Revised Remedial Plan for the Metal Bank Superfund Site

The United States and the Utility Third Party Defendants ("Utility Group") agree to this conceptual plan for remediation of the Metal Bank Cottman Avenue Site ("Site"). In September, 2002, the Utility Group submitted a Final Design Report ("Final Design") for remediation of the Site. EPA approved the Final Design in January, 2003, but the remedy in the Final Design was not implemented due to the ongoing litigation. Following approval of the Final Design, additional Site data was collected. Analysis of the new data, together with the continued evaluation of remedial options, lead the United States and the Utility Group to develop jointly a revised remedial plan. The Utility Group will agree to revise the Final Design to incorporate the changes set forth in this document, submit the revised Final Design to EPA for review and approval, and, following EPA's approval, implement the remedy set forth in the revised Final Design in accordance with a Consent Decree to be negotiated by the parties and submitted to the Court for approval. If this Revised Remedial Plan or the revised Final Design does not resolve any matter relating to t

Figure 1 SA-4/5 Excavation Areas

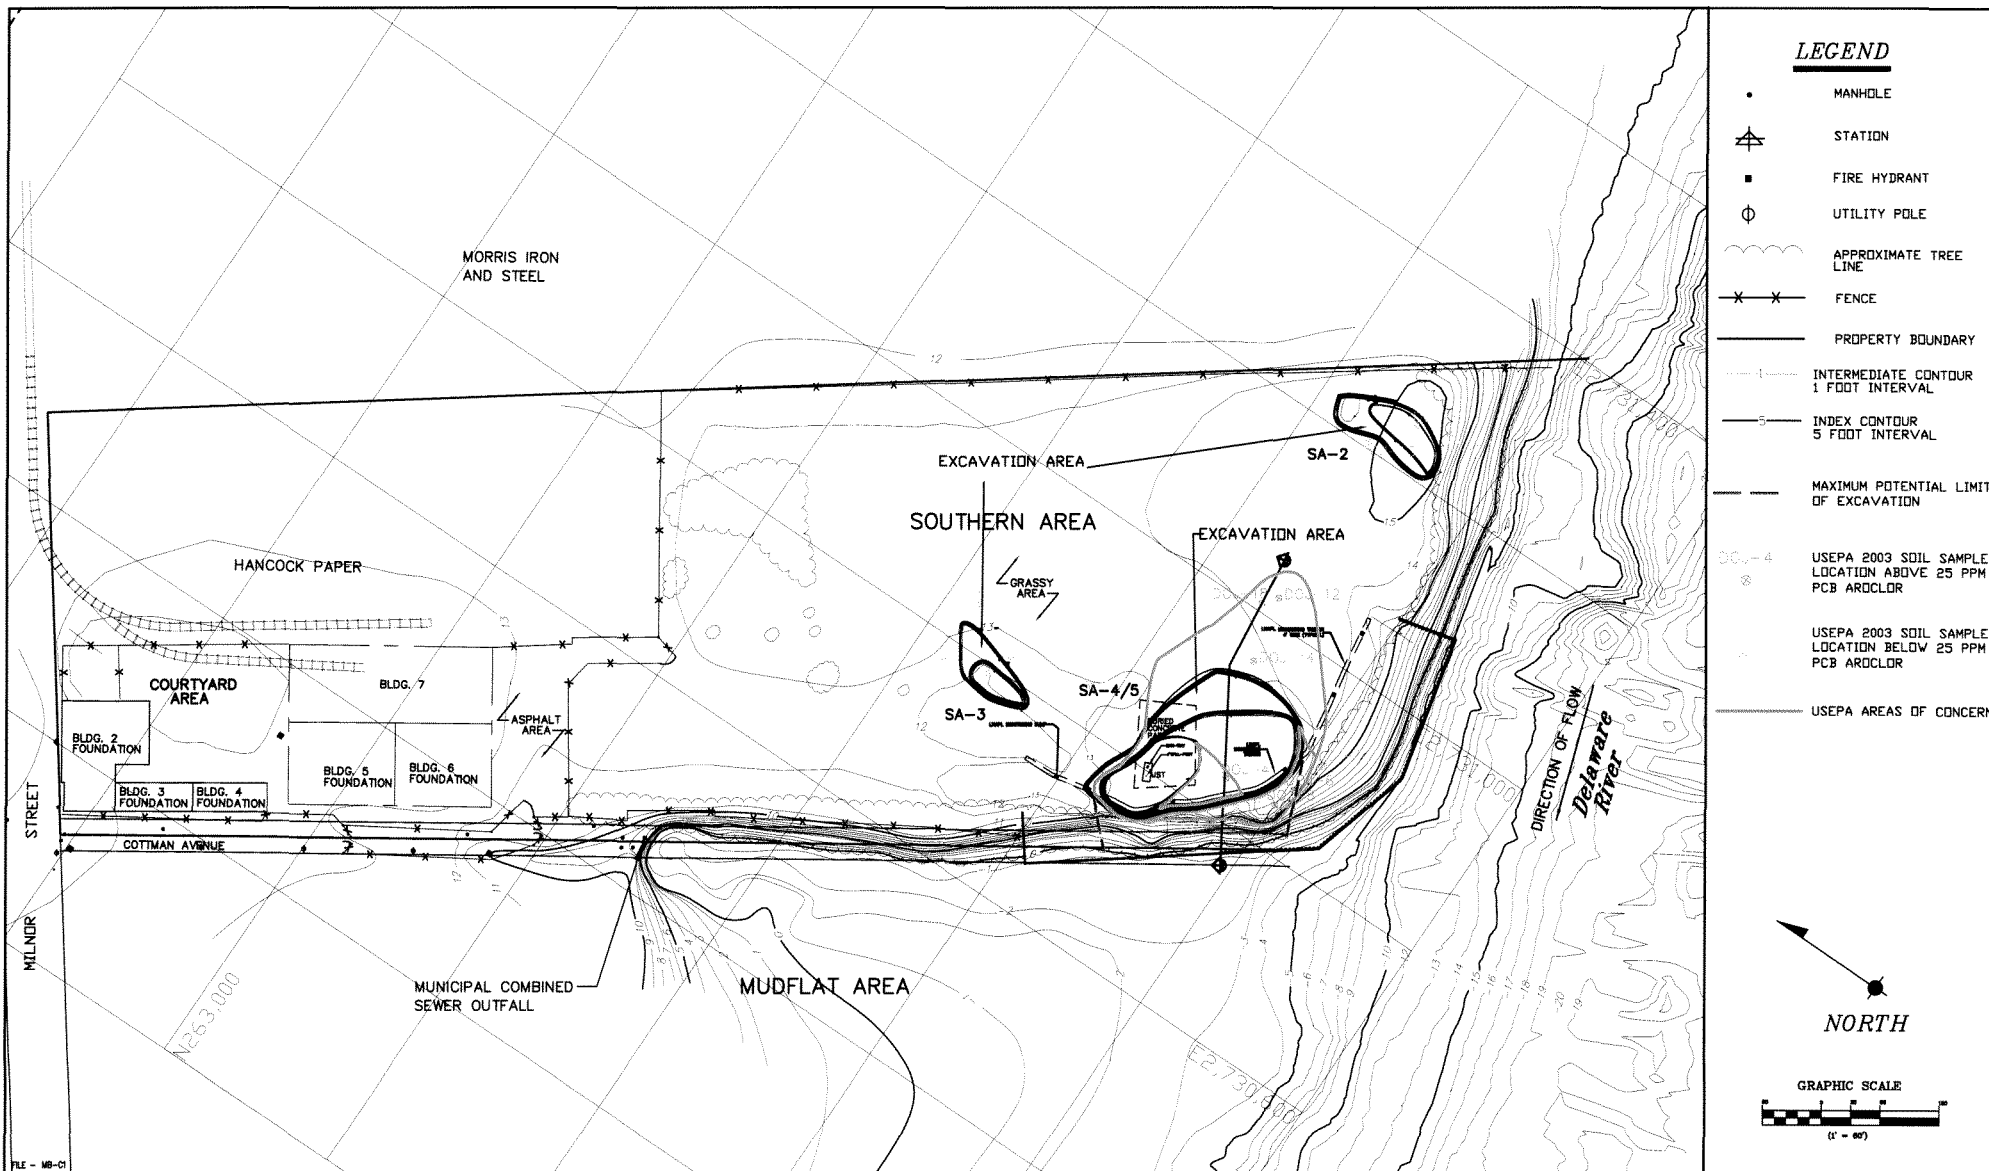
The SA-4/5 area will be excavated to the lateral extent and depths set forth in the Final Design, as modified by the changes described below. The Final Remedial Design will be revised to include these modifications. Figure 1 depicts the seven excavation areas into which SA-4/5 has been divided.

The lateral extent of the SA-4/5 excavation will be extended by 10 feet northwest from the location of sample SAB-19C towards B-15 and west towards the sheet pile wall. Figure 1 will be revised to depict the expanded excavation area and included in the revised Final Design.

Area E7 (comprised of E3 and E6) will be excavated to a depth of 5 feet below the top of the groundwater table, in the manner and under the conditions described below. EPA and the Utility Group commit to work together to design and achieve such excavation in a reasonable, safe, and cost-effective manner.

Area E4 will be capped with 4 feet of clean soil placed over a geotextile liner. Other than a slight difference in height to maintain a level slope, the other portions of SA-4/5 (E1, E2, E3, E5, E6) will be capped with 2 feet of clean soil over a geotextile liner

PROPOSED SEDIMENT EXCAVATION AND CAP

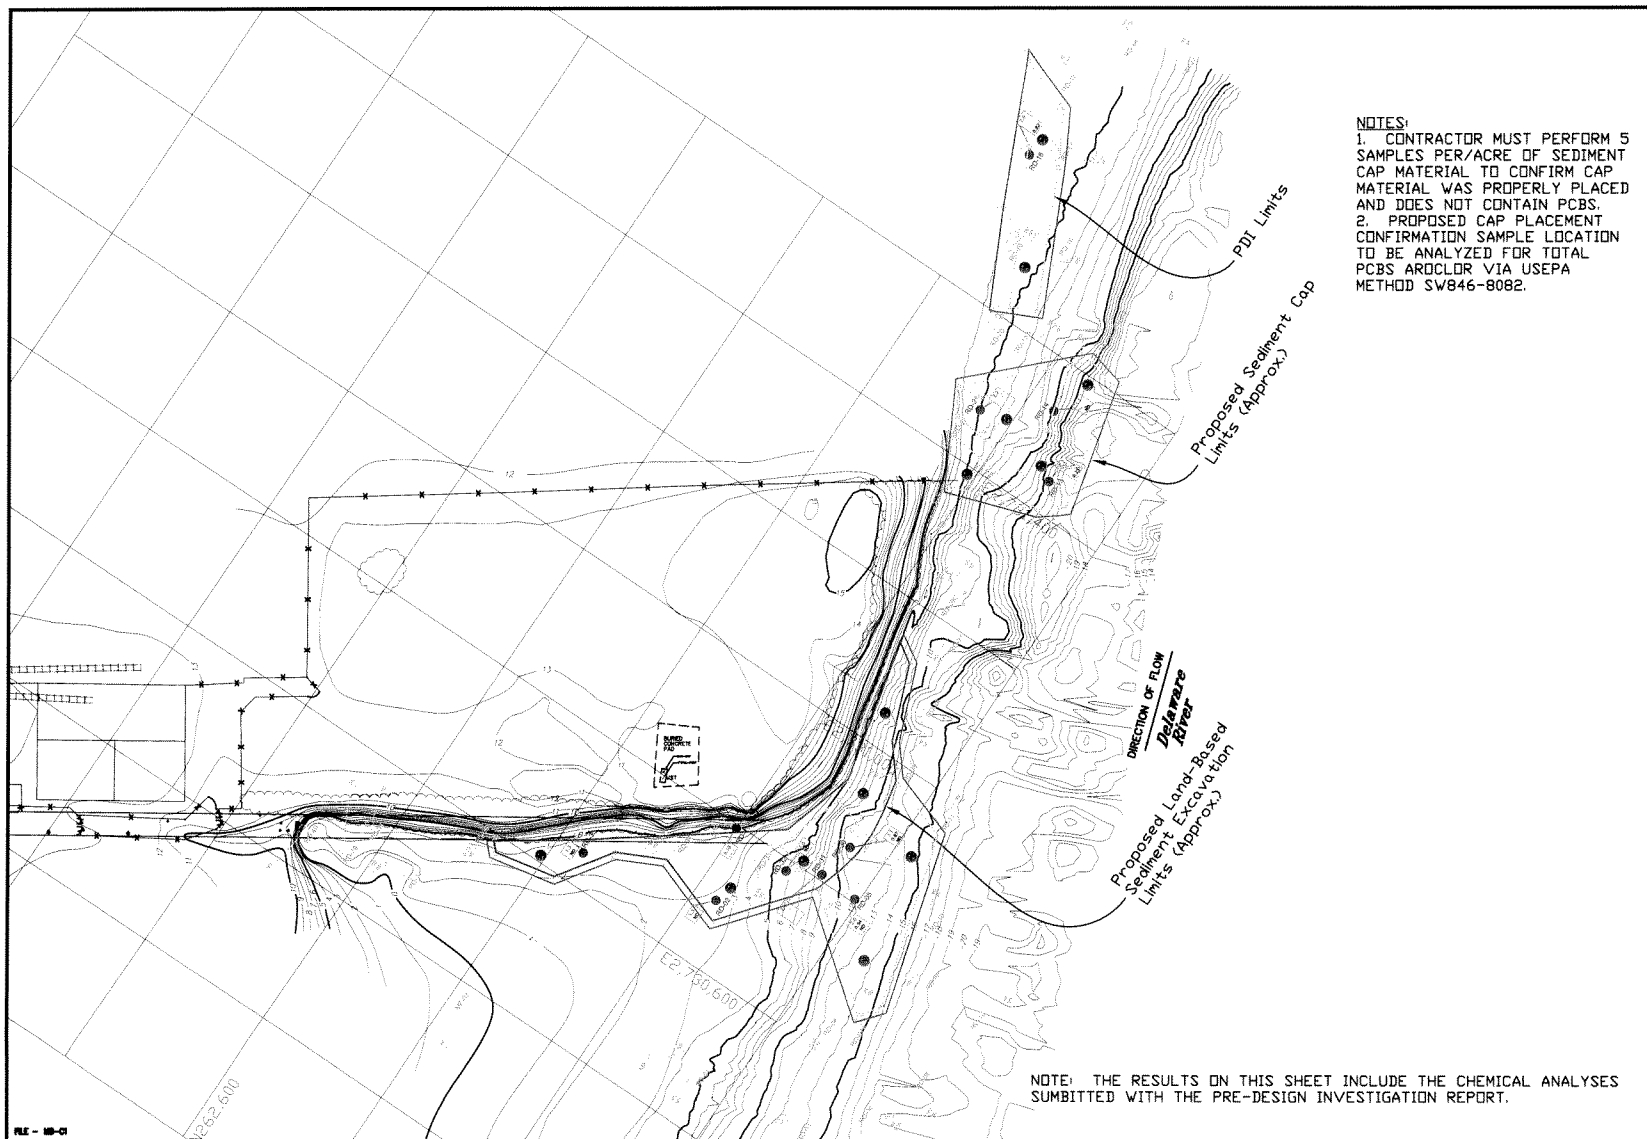
Sediments within the reach of land-based equipment, approximately 75 feet from the shore line and 2 to 4 feet from the surface, will be excavated. A sub-aqueous cap will be installed over areas outside the excavation zone that the Final Design identifies for remediation.

The areas outside the excavation zone identified in Figure 2 Drawing C-2 will be remediated using a sub-aqueous cap. The sub-aqueous cap will be approximately 24 inches thick. The Final Design will be revised to include a sub-aqueous cap design and monitoring plan for the cap areas.
